McGUIRE NUCLEAR STATION, UNIT 1

AMENDMENT TO FACILITY OPERATING LICENSE

Amendment No. 42
License No. NPF-9

Amendment No. 23
License No. NPF-17

FIGURE 2.1-1b

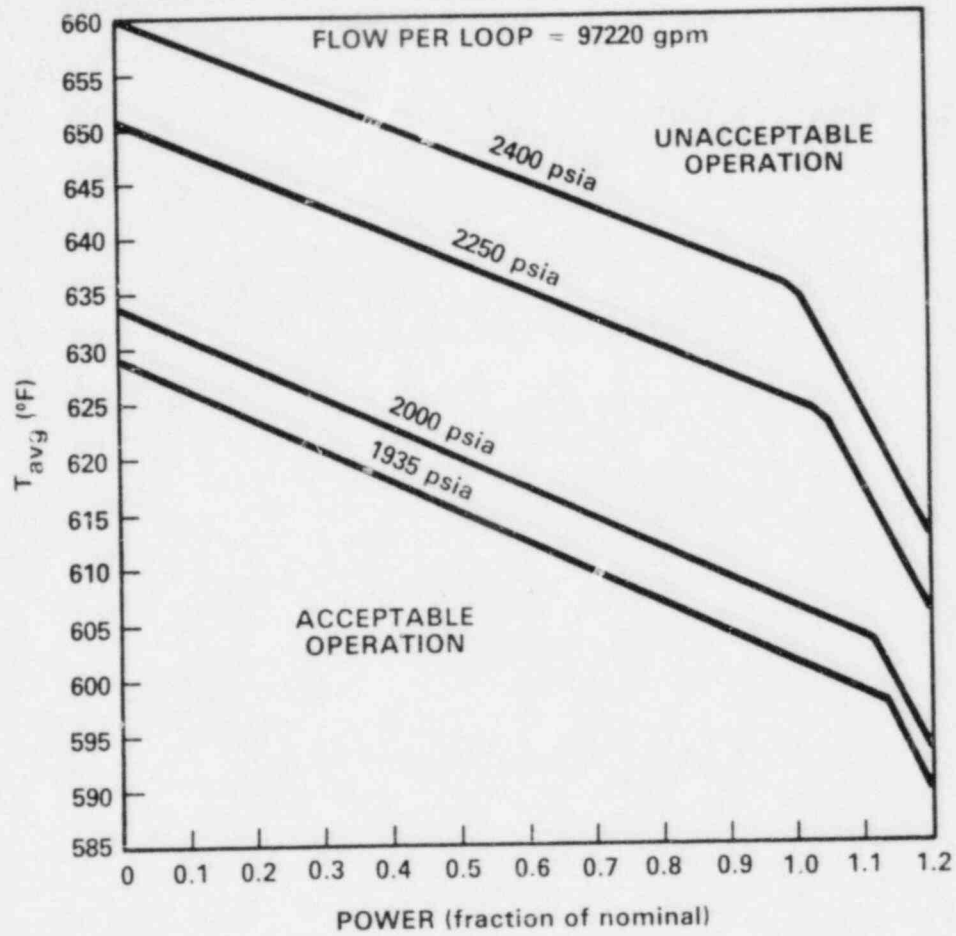
The curves of Figure 2.1-1 show the loci of points of THERMAL POWER, Reactor Coolant System pressure, and average temperature below which the calculated DNBR is no less than the design DNBR value or the average enthalpy at the vessel exit is less than the enthalpy of saturated liquid.

The curves are based on a nuclear enthalpy rise hot channel factor, $F_{\Delta H}^N$, of 1.49 and a reference cosine with a peak of 1.55 for axial power shape. An allowance is included for an increase in $F_{\Delta H}^N$ at reduced power based on the expression:

FIGURE 3.1-0
MODERATOR TEMPERATURE COEFFICIENT VS POWER LEVEL

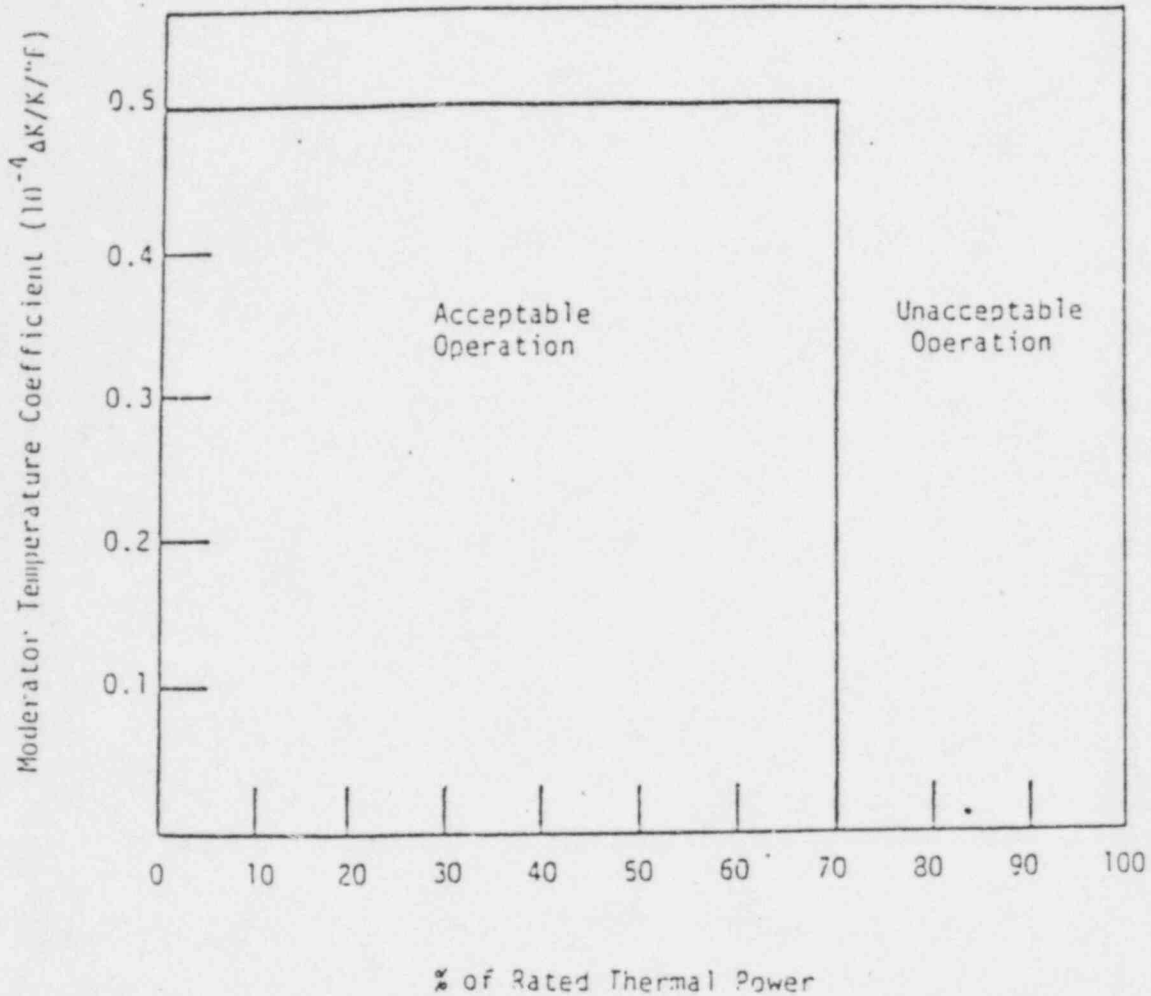
- a. Less positive than the limits shown in Figure 3.1-0, and
- b. Less negative than -4.1×10^{-4} delta k/k/°F for the all rods withdrawn, end of cycle life (EOL), RATED THERMAL POWER condition.

FIGURE 3.2-1
 AXIAL FLUX DIFFERENCE LIMITS AS A FUNCTION OF RATED THERMAL POWER

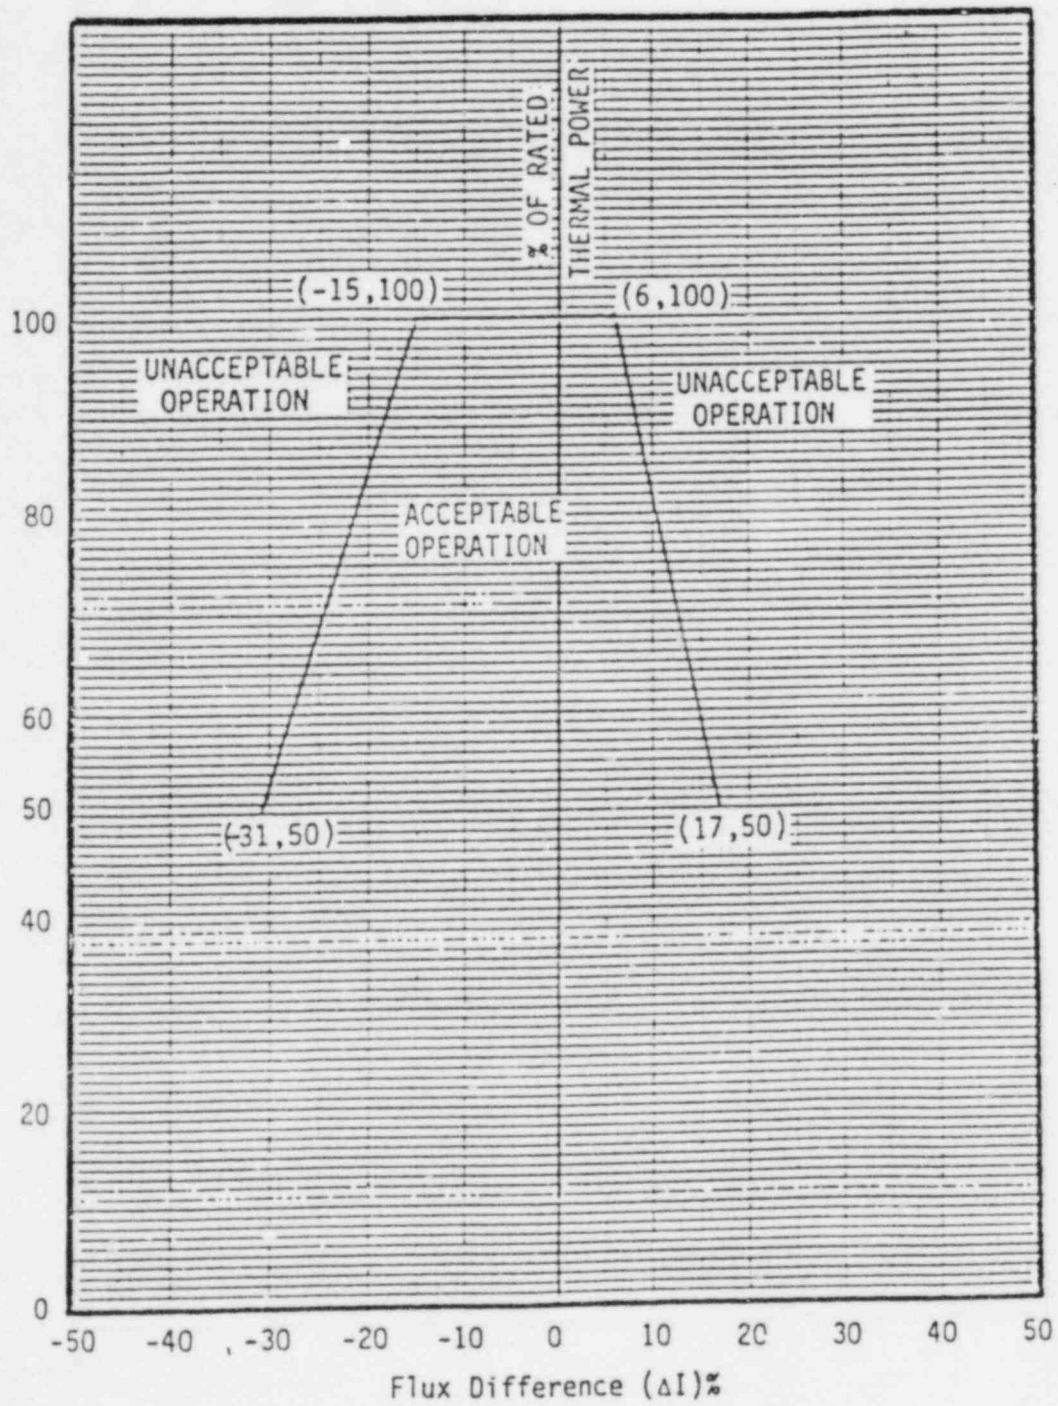
- 3.2.1 The indicated AXIAL FLUX DIFFERENCE (AFD) shall be maintained within:
- the allowed operational space defined by Figure 3.2-1 for RAOC operation, or
 - within a ± 3 (Unit 1), 5 (Unit 2) percent target band about the target flux difference during base load operation.

- For RAOC operation with the indicated AFD outside of the Figure 3.2-1 limits,
 - Either restore the indicated AFD to within the Figure 3.2-1 limits within 15 minutes, or
 - Reduce THERMAL POWER to less than 50% of RATED THERMAL POWER within 30 minutes and reduce the Power Range Neutron Flux - High Trip setpoints to less than or equal to 55% of RATED THERMAL POWER within the next 4 hours.
- For Base Load operation above APL^{ND**} with the indicated AXIAL FLUX DIFFERENCE outside of the applicable target band about the target flux difference:
 - Either restore the indicated AFD to within the target band limits within 15 minutes, or
 - Reduce THERMAL POWER to less than APL^{ND} of RATED THERMAL POWER and discontinue Base Load operation within 30 minutes.
- THERMAL POWER shall not be increased above 50% of RATED THERMAL POWER unless the indicated AFD is within the Figure 3.2-1 limits.

FIGURE 3.2-2b
 $K(Z)$ - NORMALIZED $F_Q(Z)$ AS A FUNCTION OF CORE HEIGHT (UNIT 2)

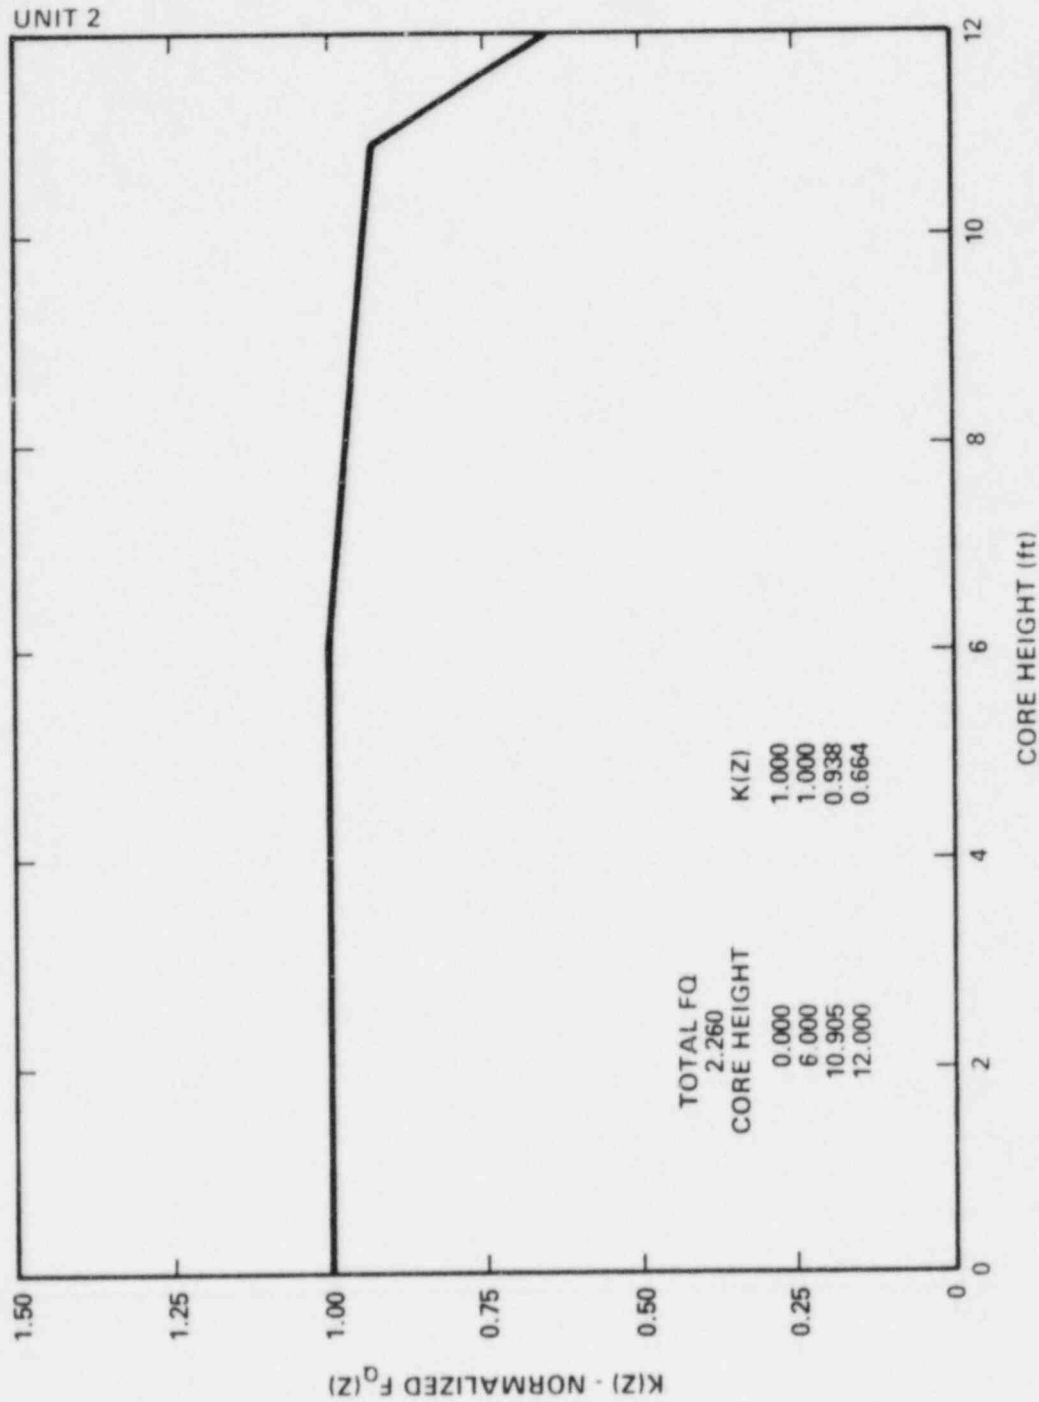
and $K(Z)$ is the function obtained from Figure 3.2-2 for a given core height location.

where $F_Q^M(z)$ is the measured $F_Q(z)$ increased by the allowances for manufacturing tolerances and measurement uncertainty, 2.15 (Unit 1) and 2.26 (Unit 2) is the F_Q limit, $K(z)$ is given in Figure 3.2-2, P is the relative THERMAL POWER, and $W(z)$ is the cycle dependent function that accounts for power distribution transients encountered during normal operation. This function is given in the Peaking Factor Limit Report as per Specification 6.9.1.9.

Figure 3.2-3b RCS Flow Rate Versus R - Four Loops in Operation (Unit 2)

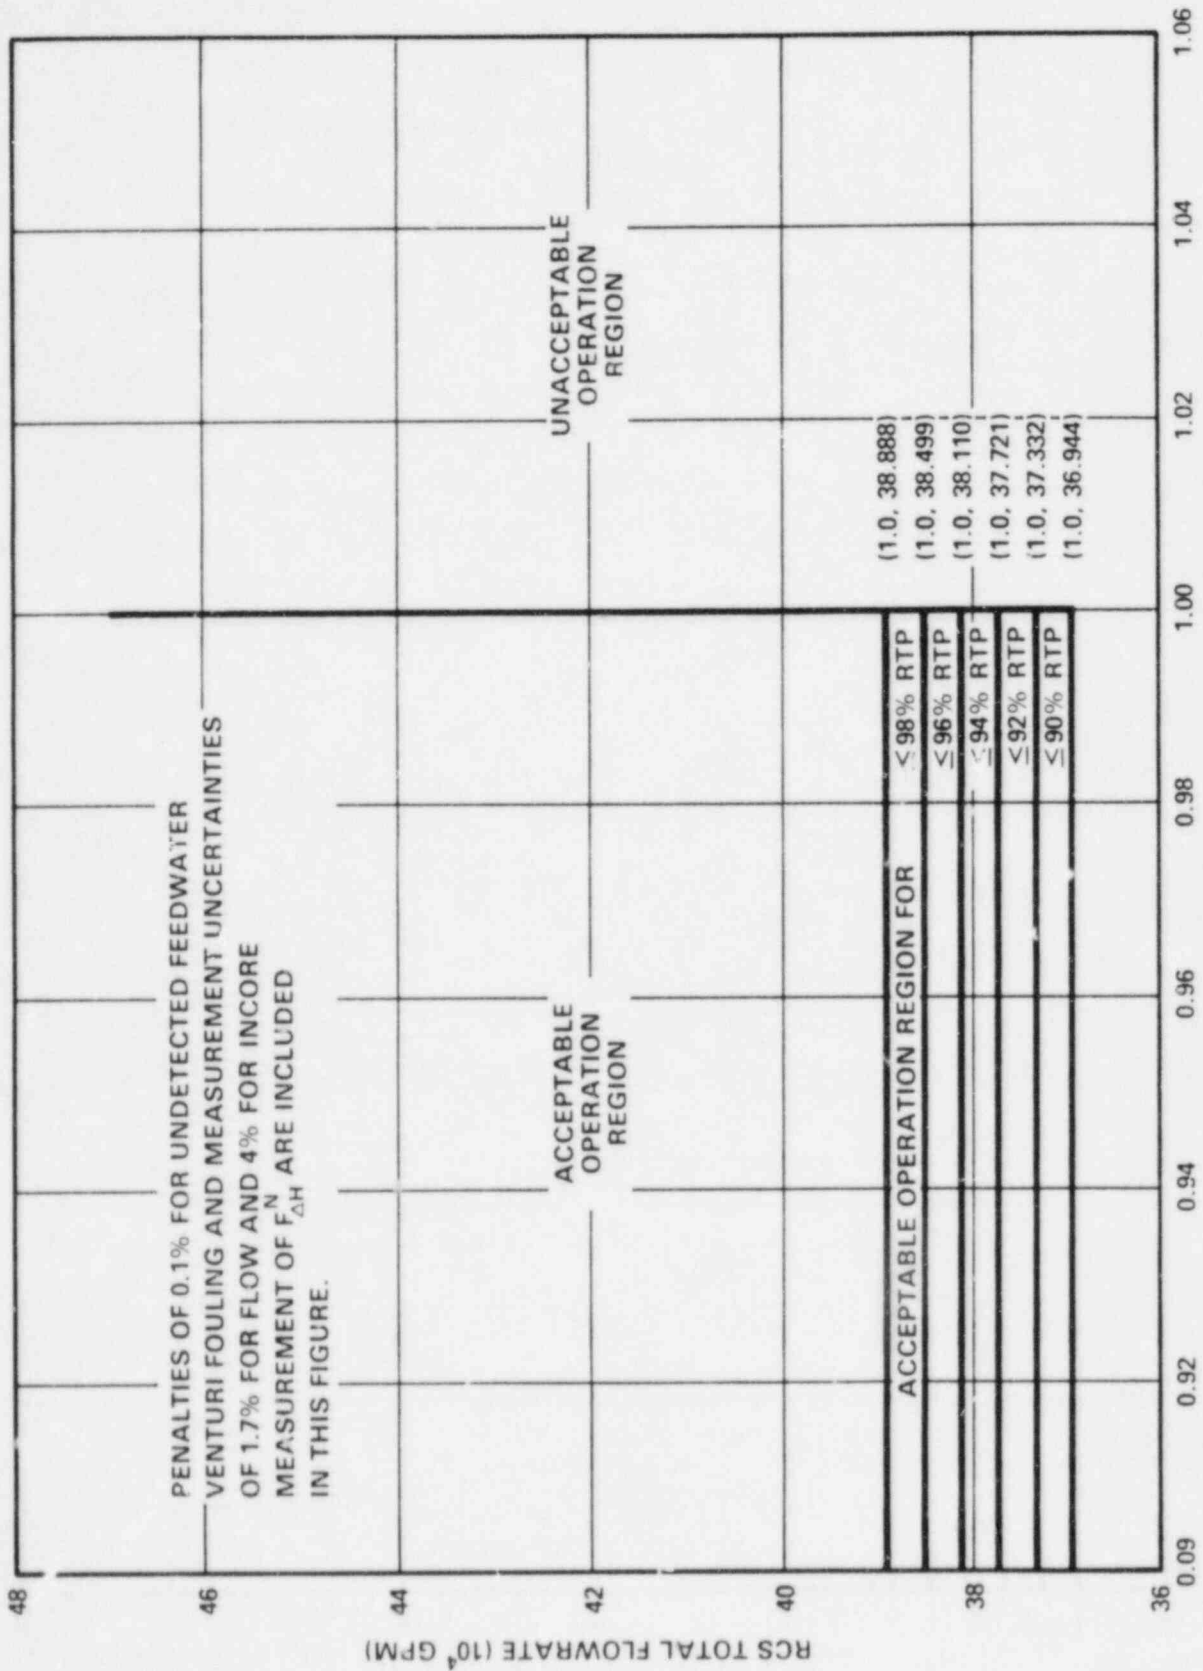
3.2.3 The combination of indicated Reactor Coolant System (RCS) total flow rate and R shall be maintained within the region of allowable operation shown on Figure 3.2-3 for four loop operation:

c. $F_{\Delta H}^N$ = Measured values of $F_{\Delta H}^N$ obtained by using the movable incore detectors to obtain a power distribution map. The measured values of $F_{\Delta H}^N$ shall be used to calculate R since Figure 3.2-3 includes penalties for undetected feedwater venturi fouling of 0.1% and for measurement uncertainties of 1.7% for flow and 4% for incore measurement of $F_{\Delta H}^N$.
